U.S. CONSUMER PRODUCT SAFETY COMMISSION
4330 EAST WEST HIGHWAY
BETHESDA, MD 20814

March 10, 2011

On December 22, 2010, the U.S. Consumer Product Safety Commission (CPSC) staff received the Canvass Draft of the proposed American National Standard for Recreational Off-Highway Vehicles, ANSI/ROHVA 1-201X.¹ CPSC staff has reviewed the draft standard and continues to believe that the proposed standard does not adequately address vehicle stability, vehicle handling, and occupant retention and protection.

Figure 1. Modifications to ROV to improve steering characteristics.

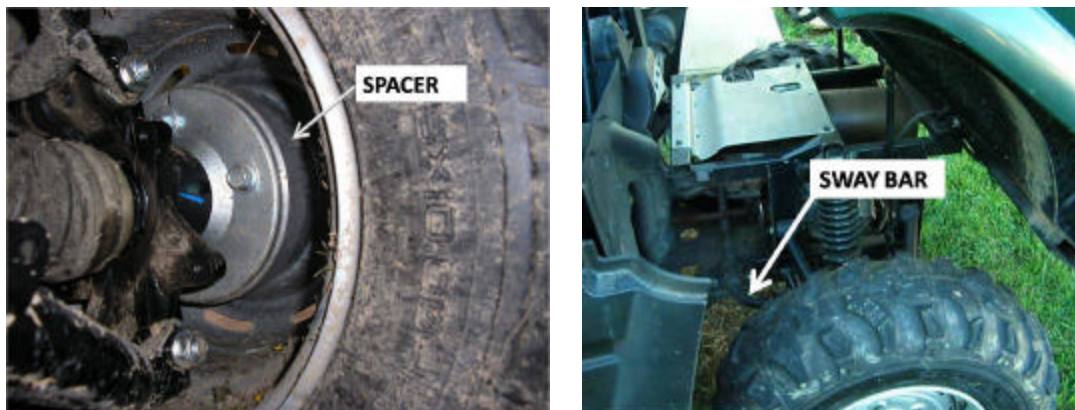
CPSC staff continues to believe that steady state oversteer is an undesirable and unstable steering control mode for ROVs. Therefore, staff believes that a test to measure steering gradient and an acceptance criterion for handling characteristics is necessary for ROVs. CPSC staff's experience with vehicle dynamic testing has shown that altering the steering characteristics of a vehicle is not difficult. Staff successfully altered the steering characteristics of a vehicle that originally exhibited steady state oversteer by performing minor modifications to the vehicle's track width and suspension stiffness. The modifications to the vehicle consisted of adding spacers to the rear wheels and removing the rear sway bar (see Figure 1).

Figure 2. Steering diagram of unmodified vehicle and modified vehicle in clockwise (CW) and counterclockwise (CCW) directions.

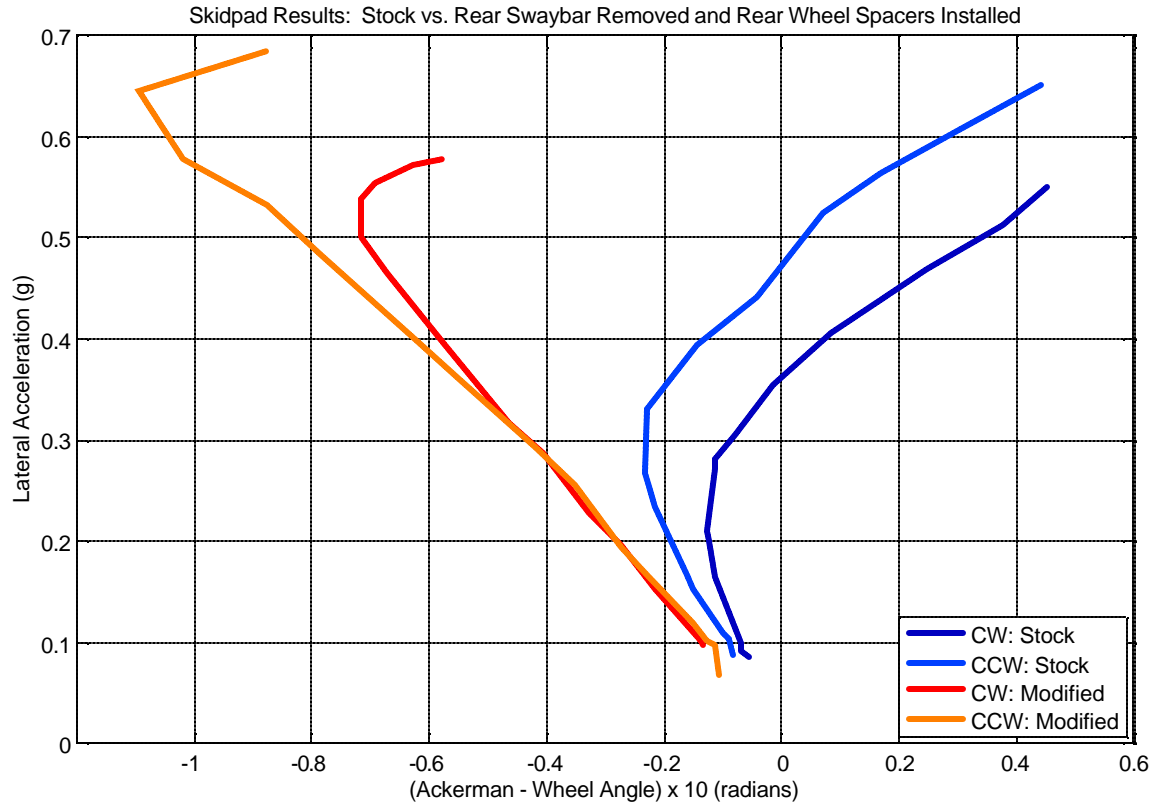
The effectiveness of the modifications in improving the vehicle from oversteer (blue lines) to understeer (red and orange lines) is illustrated in the vehicle diagram shown in Figure 2.
